NOTICE OF DECISION

DATE:July 17, 2023PROJECT NAME:Earsley Investments Car DetailingPROJECT LOCATION:106 & 108 Yelm Ave W, Yelm, WA 98597PARCEL NUMBER(S):85800100100 & 85800100200CASE NUMBER:MU 2022.0065

Administrative Site Plan Review mu 2022.0065 Findings of Fact, Conclusions of Law, and Decision

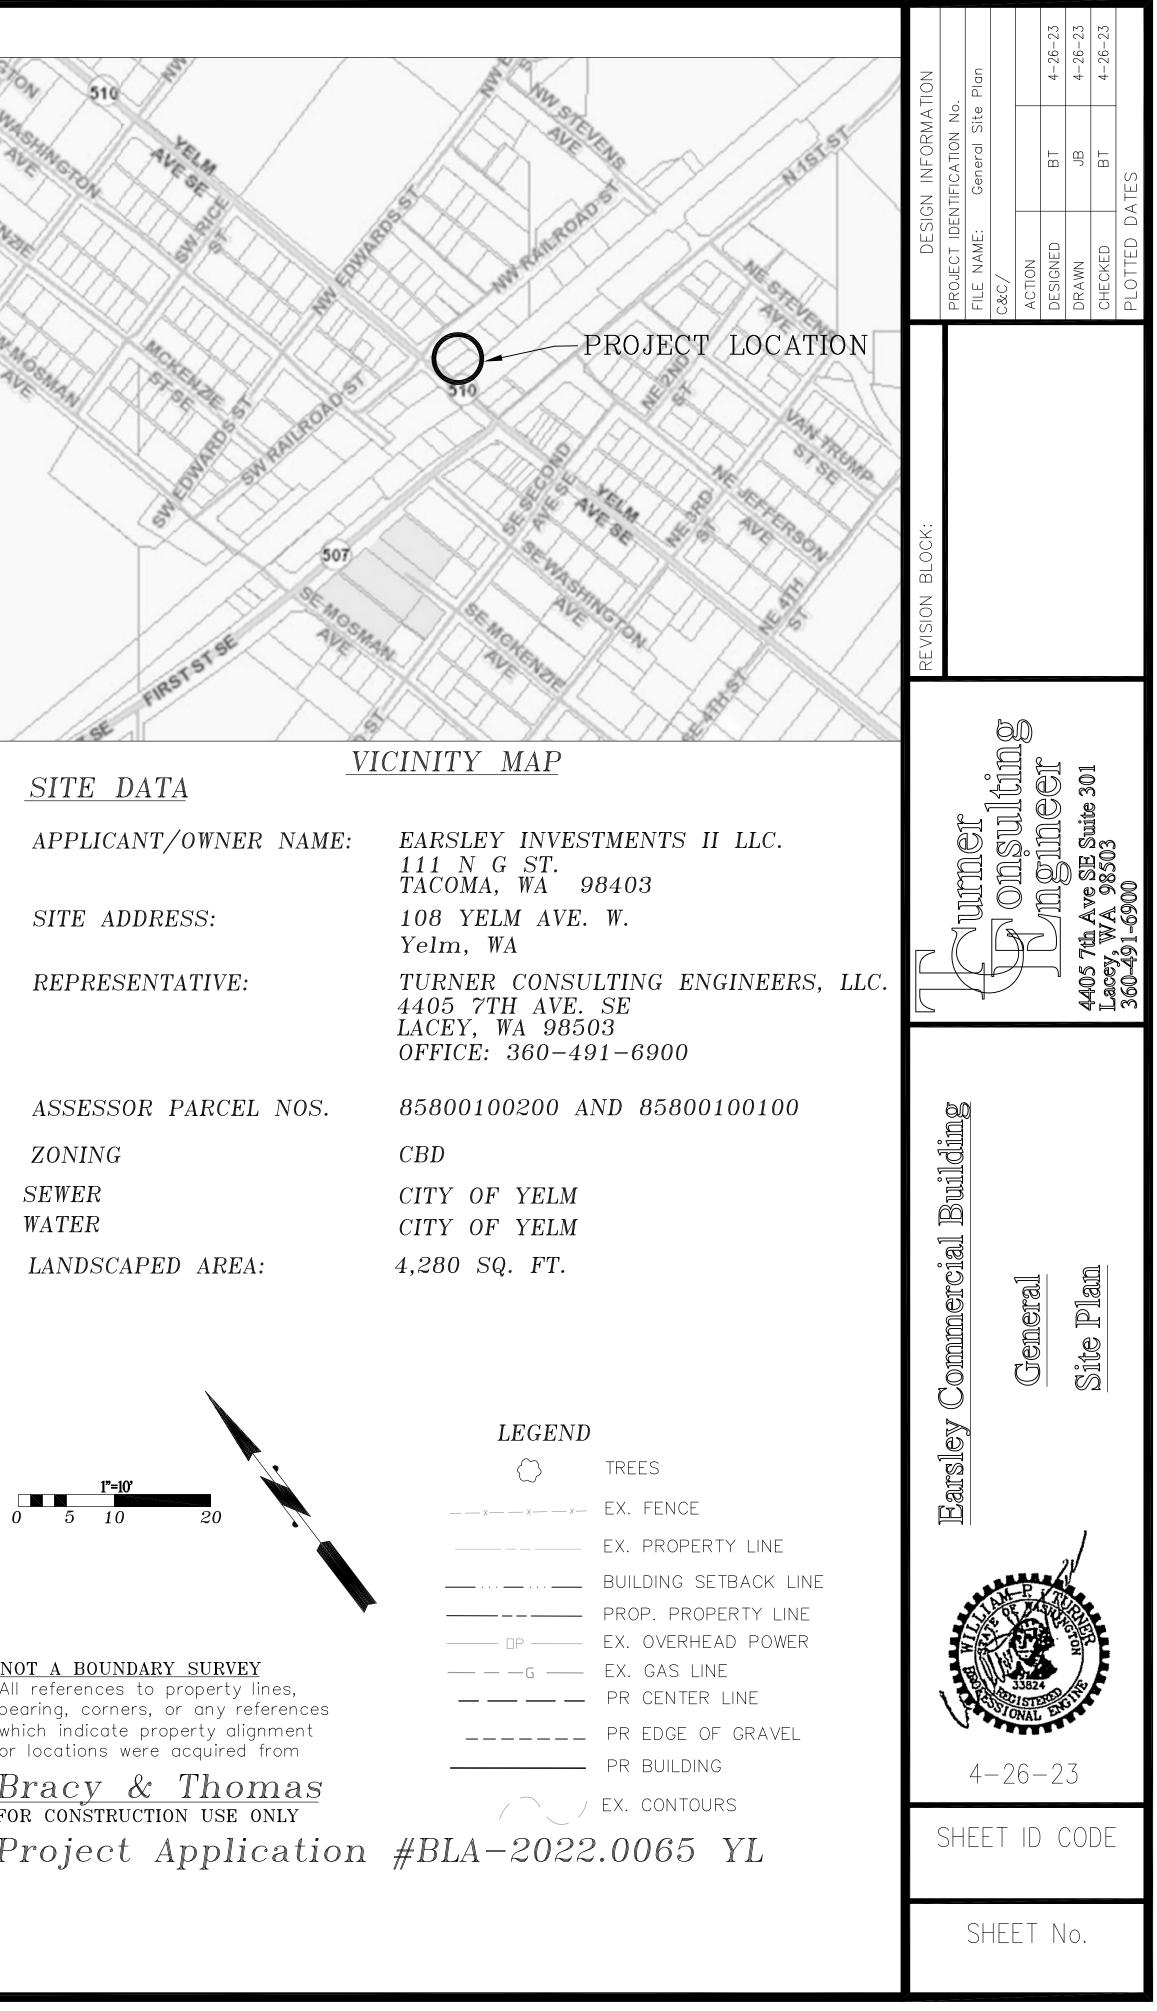
- 1. All the comments shown on the site plan must be addressed.
- 2. The review comments on the landscape plan haven't been addressed yet. A landscape plan that complies with all City rules and Unified Development Code requirements must be submitted with the civil plans.
- 3. The Fire Impact Fee must be paid at the time the building permit is issued.
- 4. Traffic Facility charges are required at the time the building permit is issued.
- 5. The property borders by Yelm Avenue West and Railroad Street Northwest, both of which are not up to City standards. To satisfy City standards, the Railroad Street NW side of the property must be improved.

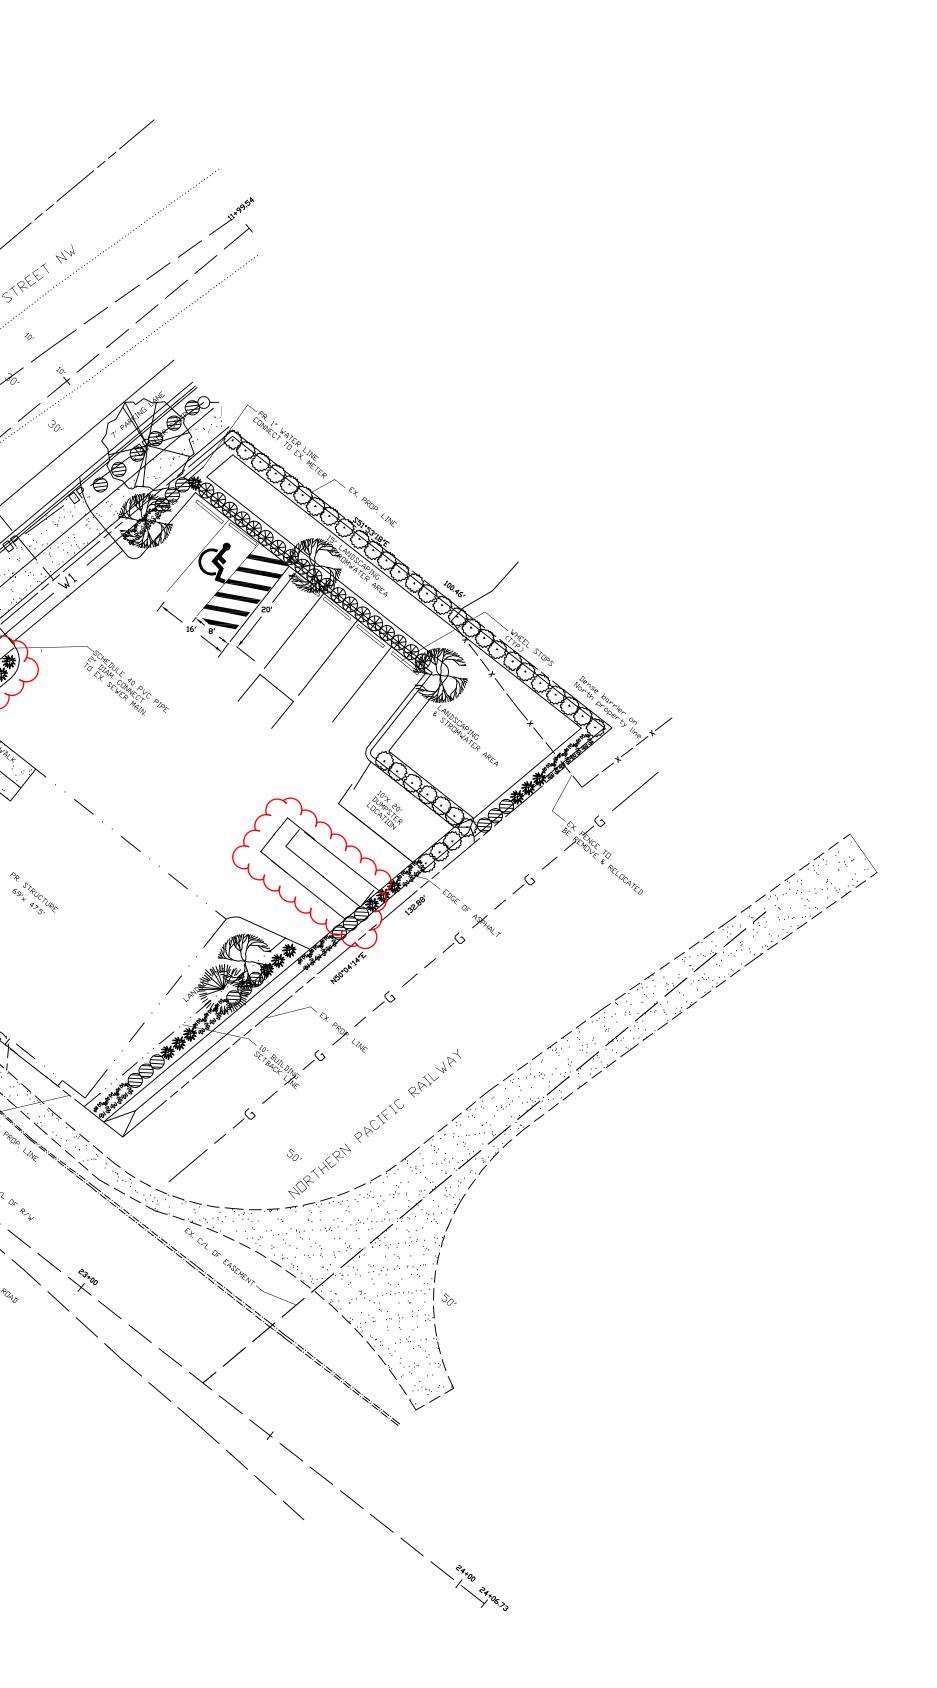
- The planter strip need to be measured from the edge of the sidewalk to the back of the curb (Please see the attached detail that is extracted and marked up from the city of Yelm Development Guidelines Chapter 2 Transportation Details (Link))

- No shrubs, bushes, or ground cover vegetation other than grass shall be planted within a 5' radius of any tank lid. No trees shall be planted within 10' of any tank lid or valve box. All of the tank lids shall be visible.

- The new site plan and landscaping plan submissions are not consistent. The new site plan has only one page whole the previous ones have two pages with the detail on street Tree.

- The comments that highlighted on the plans were ignored such as fonts, ...
- The FOG program is something required on civil plans, but if a grease interceptor or water/oil separator is decided then the tank location should be shown on the site plan as well.
